Service Bulletin

Bulletin No. 2006-08

Revision to Recall Notification 96-13: Commander 3000 Remote Control Product Update

| NOTICE | |
|---|--|
| This Bulletin supersedes MerCruiser Service Bulletin 96-13. | |

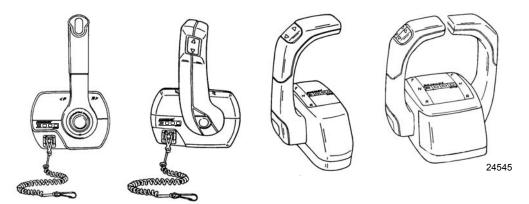
Commander 3000 remote controls built between June 1, 1994, and September 1, 1995, could fail, resulting in the inability to reduce throttle, or shift the engine out of gear. Failure is caused by an improperly hardened gear in the control mechanism.

Due to parts availability issues, the repair procedure has been revised to include new part numbers for the replacement controls and cables.

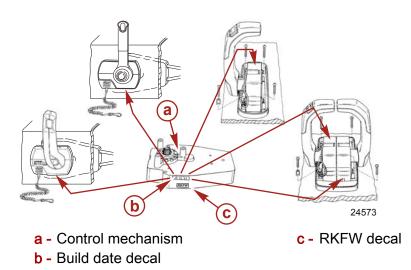
- 2. **Rework Identification:** Commander 3000 remote controls built between June 1, 1994, and September 1, 1995, that have been reworked at the factory have a decal with the letters "RKFW" on the control. The affected gear has been replaced on these controls and the control is approved for use.
- Determine whether you have a Commander 3000 control that is included in this
 recall. View the decals on the control, if visually accessible, in the location shown
 below. Use a flashlight and mirror to help read the decals.

IMPORTANT: If your remote control was built between June 1, 1994, and September 1, 1995, and does not have a "RKFW" decal, you are affected by this recall and must have the control mechanism replaced.

The mechanism of Commander 3000 remote controls built between June 1, 1994, and September 1, 1995, that do not have the "RKFW" decal, and those found with no build date must be replaced with a Gen II Remote Control, and Gen II Cables as described in the tables below. The Gen II Remote Control must be used with Gen II Cables for this replacement as the Gen I Commander 3000 Remote Controls are no longer available (NLA).
